**FINAL  
ENVIRONMENTAL IMPACT REPORT**

**HARPER CANYON (ENCINA HILLS)  
SUBDIVISION**

SCH# 2003071157  
PLN 000696

## 2.0 RESPONSE TO COMMENTS

Figure MR2-1  
14 Legal Lots of Record

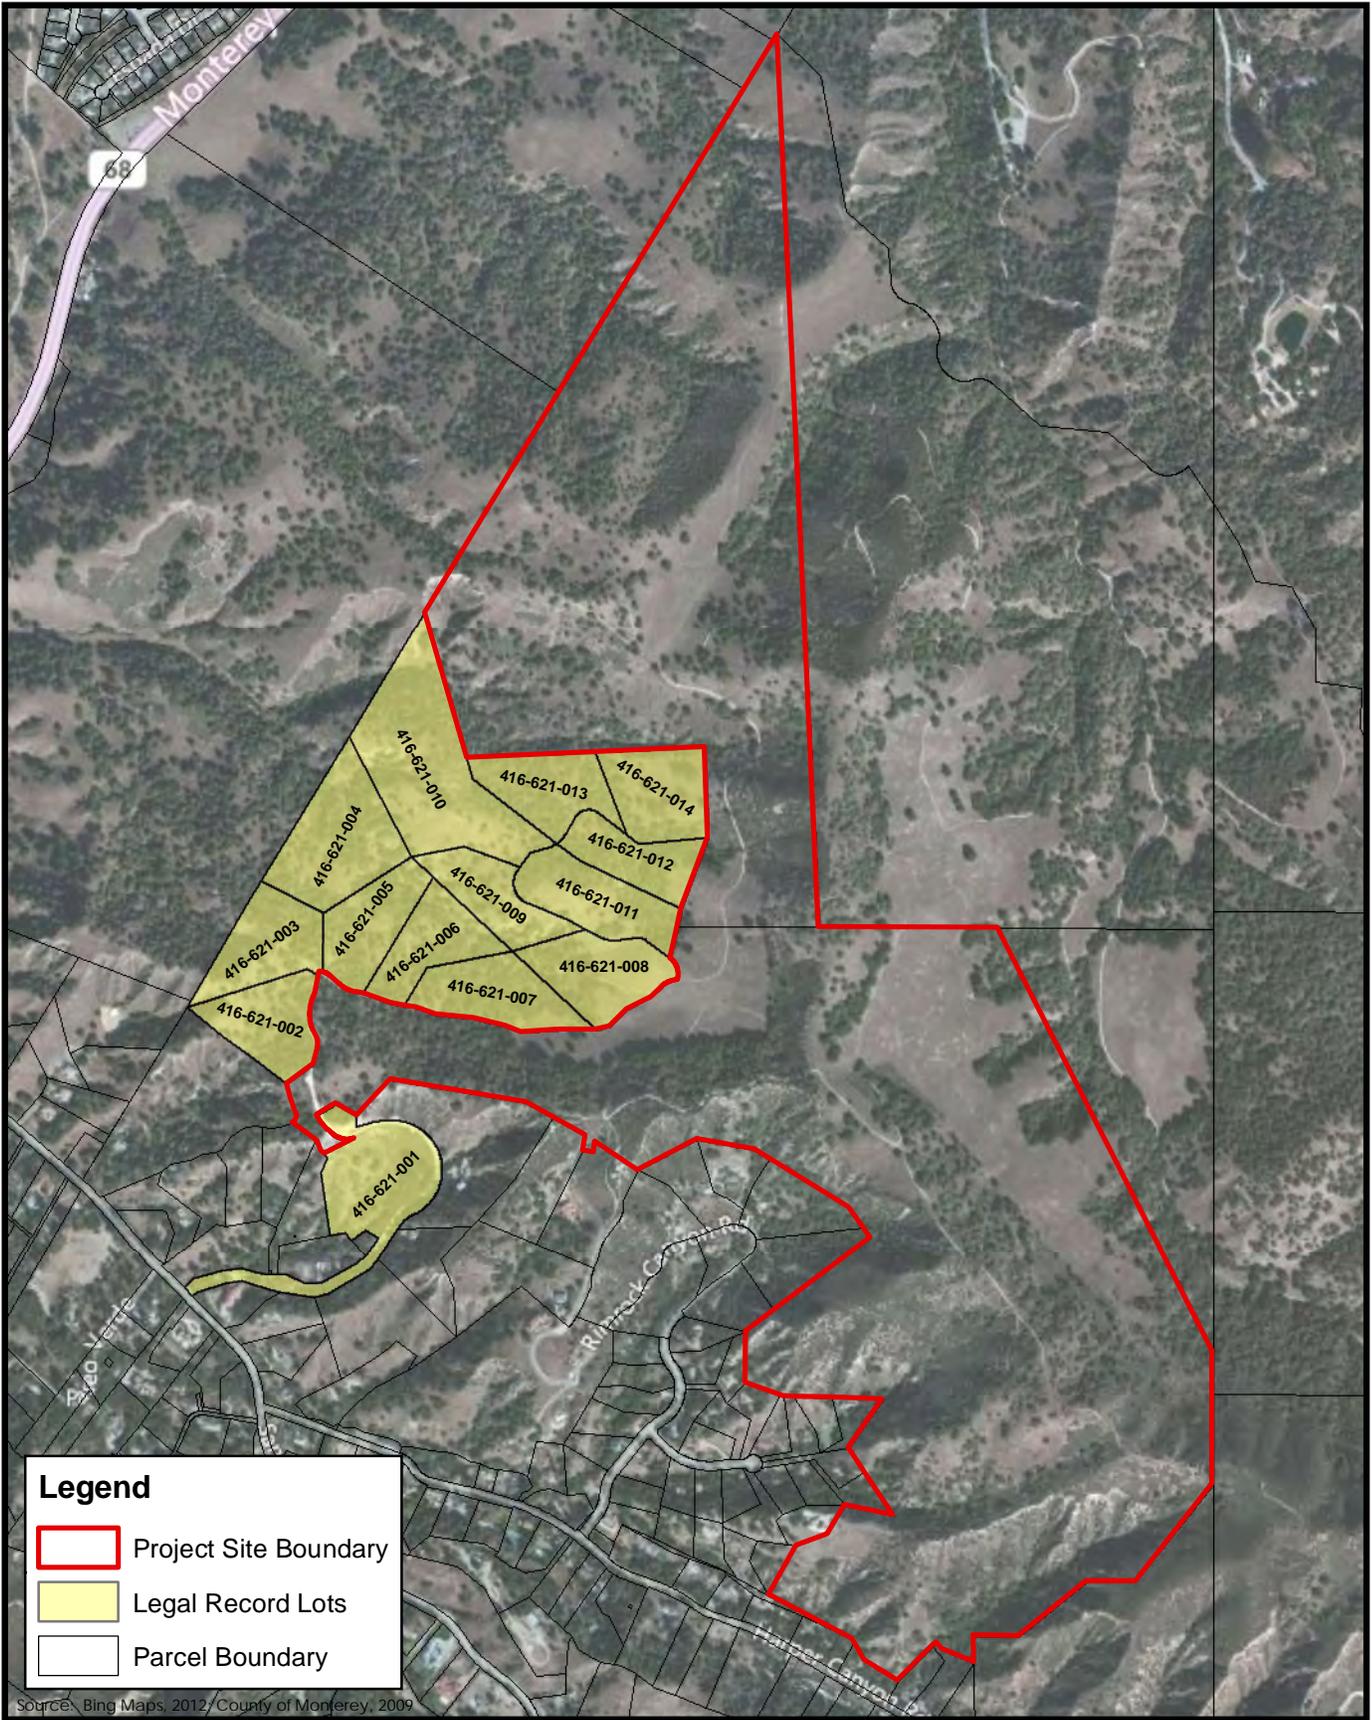
Several comments were received regarding the 14 existing lots of record (“Broccoli lots or parcels”) that are located adjacent to the project site (see **Figure MR2-1**). These 14 lots of record are owned by the project applicant, and were recorded in their current configuration in 1993. Fifteen lots on this property existed prior to 1993, but were adjusted via a major lot line adjustment approved by the County Subdivision and Minor Subdivision Committee. The adjustment resulted in the 14 lots plus one large remainder lot. That remainder lot of 343 acres is the area now proposed for the Harper Canyon/Encina Hills subdivision. The approval of the 1993 lot line adjustment contained several conditions of approval, and the approval was subject to the environmental and planning review procedures per the County’s process in place at the time. A negative declaration was prepared, considered and approved as part of the Committee’s action.

First, the 15 legal lots of record exist already. As such, the lots could be developed at any time if the attached conditions of approval are met and once proposed development (home sites) satisfy the County review and permit process. At any time the property owner could improve and extend Meyer Road and provide utility extensions to the existing 14 lots consistent with the terms of their approval. The development of the Broccoli lots is not dependent upon the approval of the Harper Canyon/Encina Hills Subdivision nor dependent upon access easements, as all lots in question are held in single ownership. The 1993 lot line adjustment was approved with the understanding that the lots would be accessed by an improved Meyer Road. The California Environmental Quality Act (CEQA) does not require re-analysis of a previously approved project unless ordered by a court of law following a successful challenge of the approval, or substantial changes are made to the project prior to development that triggers such analysis. No such conditions exist, no changes are being considered with respect to the 14 existing lots, and no specific development is proposed on the lots at this time.

specific issue of water service for the 14 lots, these legal lots are located in Cal-Am's service area, and the lots pre-date the B-8 zoning restrictions.

Regarding the DEIR's approach to assessing cumulative effects, the existing 14 lots have been documented, recognized and included under background conditions as an "approved project" since the property owner could apply at any time for a building permit on those lots provided the property owner can meet conditions of approval and building requirements. Please see DEIR page 5-5, Table 5-1, Cumulative Projects which identifies the 14 lots of record. The existing 14 lots have been included in the analysis assumptions throughout the DEIR document and Chapter 5.0 Cumulative Impact Summary. The DEIR (and RDEIR dated December 2009) identified that the project's contribution to all cumulative effects were either effectively mitigated by the project's mitigation measures, or otherwise did not result in a cumulatively considerable environmental impact.

Figure 3.7-1  
U.S. Geological Survey Watersheds within Monterey County

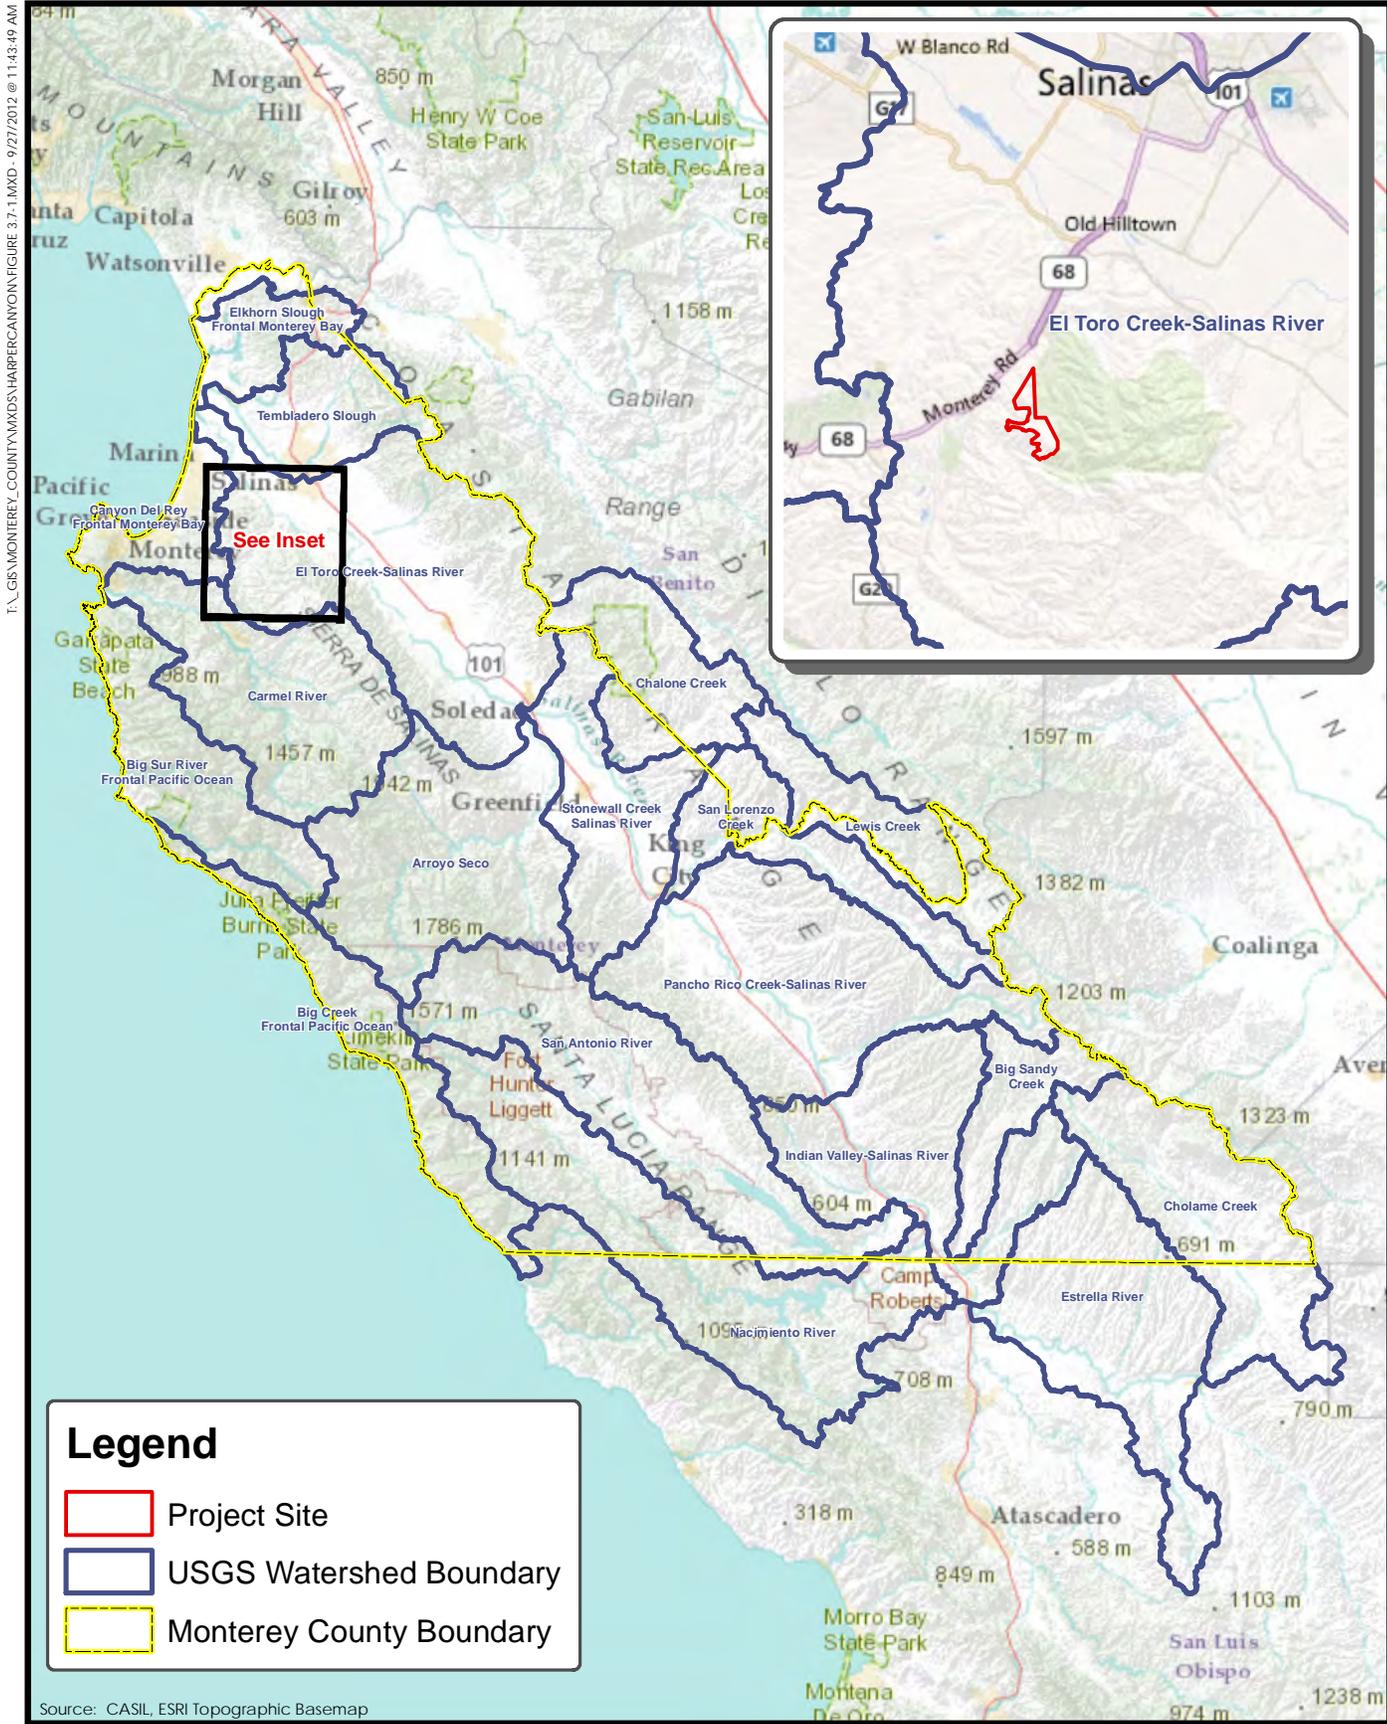
~~The project site is located in the southeastern section of the Monterey Peninsula~~El Toro Creek-Salinas River subarea of the Salinas watershed as shown in **Figure 3.7-1**. The Salinas Valley drains an area of approximately 3,950 square miles to the Salinas River. The watershed basin consists of deep alluvial deposits that are several hundreds of feet thick. The groundwater basin in this area is recharged primarily through percolation from the Salinas River during the rainy season. Average annual flows to the ocean from the Salinas River are approximately 282,000 acre-feet per year (AFY) during the spring and summer months. The two reservoirs on the Nacimiento and San Antonio Rivers regulate flow to minimize outflow to the ocean and to maximize groundwater recharge through the Salinas River bed.

On page 3.7-3 of the DEIR a new **Figure 3.7-1, U.S. Geological Survey Watersheds within Monterey County** figure has been added before section 3.7.2, Regulatory Setting. This added figure subsequently renumbered **Figure 3.7-1, Watersheds and Proposed Detention Basins** as **Figure 3.7-2**. All references to **Figure 3.7-1, Watersheds and Proposed Detention**

Basins throughout the DEIR have subsequently been revised to reference **Figure 3.7-2, Watersheds and Proposed Detention Basins.**
